# Portal Associations in P802.1CS D2.1

Norman Finn  
Huawei Technologies Co. Ltd  
cs-finn-portal-associations-0319-v2

# P802.1CS D2.0

Figure 6-8—State machine creation

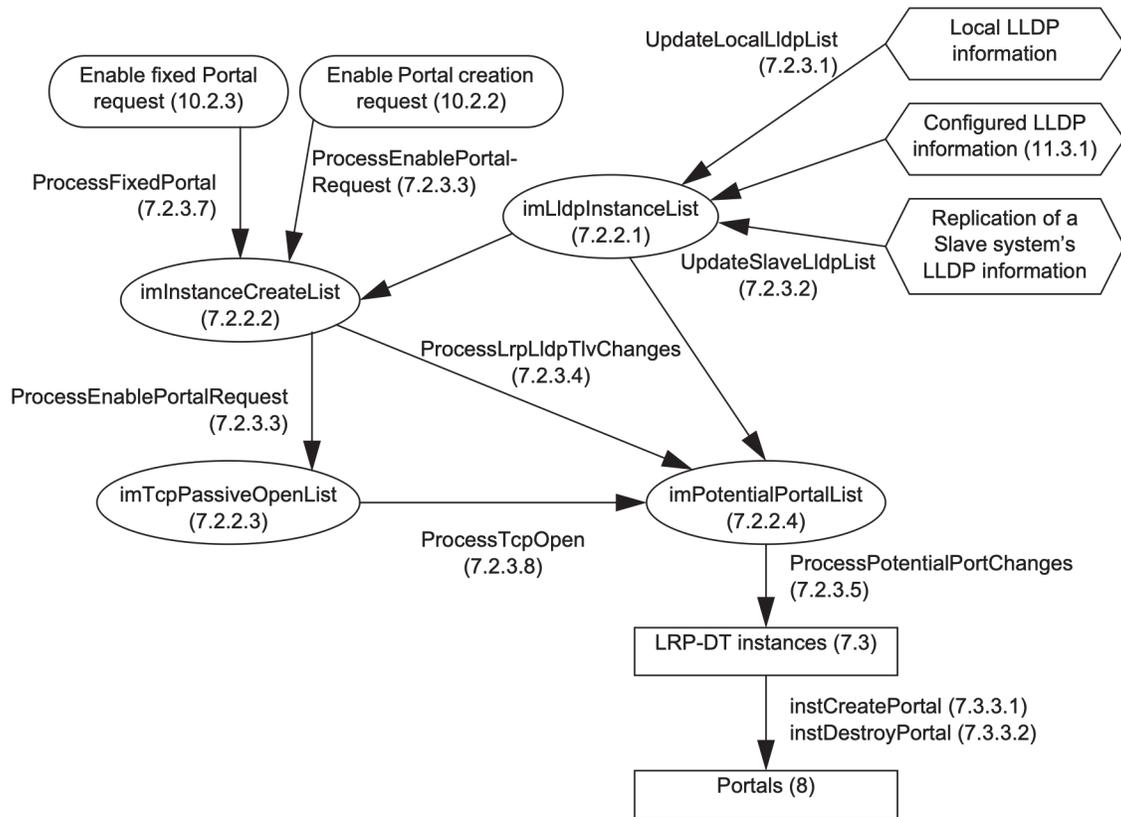
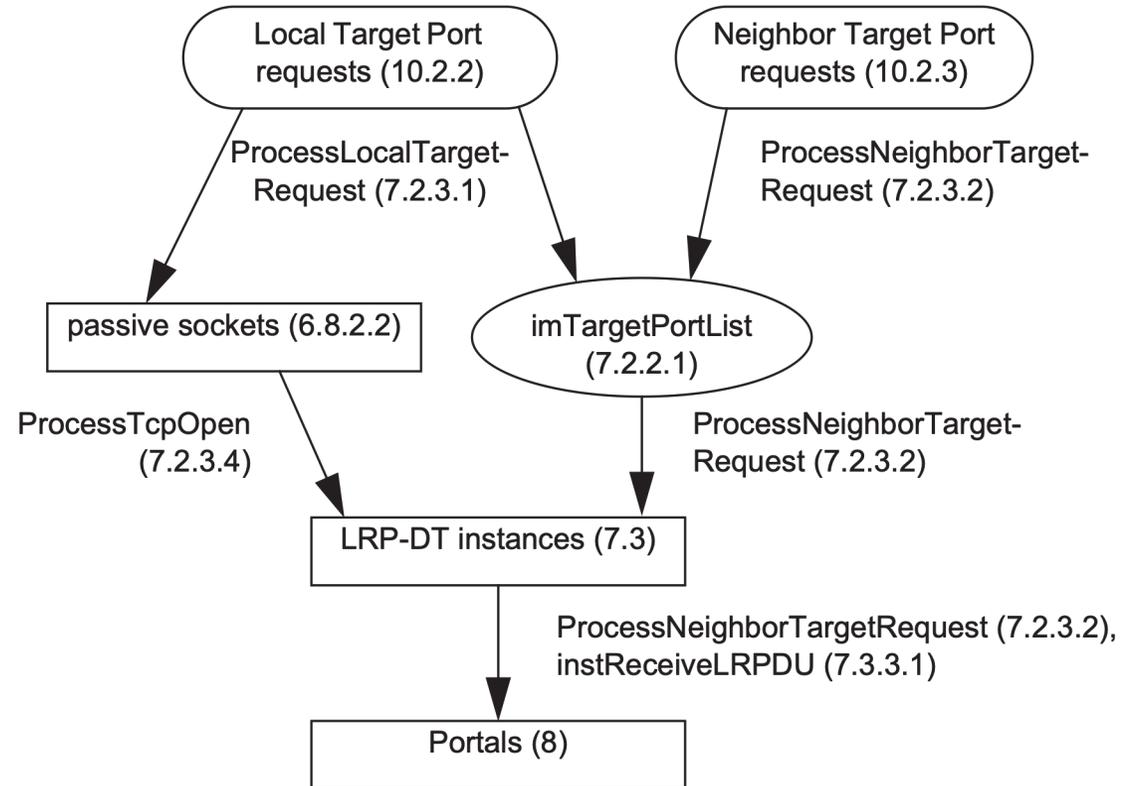
1. Clause 7.2 of IEEE P802.1CS D2.0 (the January 2019 draft), which describes state machine creation, was very complex and tied tightly to LLDP, even though LLDP was not required.
2. The text in D2.0 was somewhat confused, especially in the descriptions of the primitives in Clause 10, between the creation and the operation of the LRP-DT and LRP-DS state machines.
3. The descriptions of TCP operations were vague.
4. Bottorff and Congdon suggest simplifying the state machine creation mechanism and decoupling LLDP from control of LRP by the application.

1. The application creates (via primitives) local target ports and attaches remote target ports to them. (This database can be the same information that is supplied by LLDP, if desired.)

2. This database creates LRP-DT instances and, if the remote target information is complete, Portals, and the Portals start Hello transmission.
3. Passive TCP LRP-DT instances are always created. Receipt of an incoming connection creates a Portal that does **not** yet send Hellos.

4. The same non-sending Portal is created for an ECP LRP-DT instances if the an ECP local target port is given, but no remote target port.
5. When a Hello is received, the local target port it names must exist. Whether remote target port is in the table or not, Hello is offered to application, and if approved, Portal is created (if necessary), the remote port is added to table (if necessary), and Hellos begin transmission (if not already being sent). If not approved, nothing changes.

6. **Application controls the table** – not LLDP or LRP directly – so Portals and LRP-DT instances are solely by 1) manipulating the table and 2) the receipt of Hello LRPDUs.
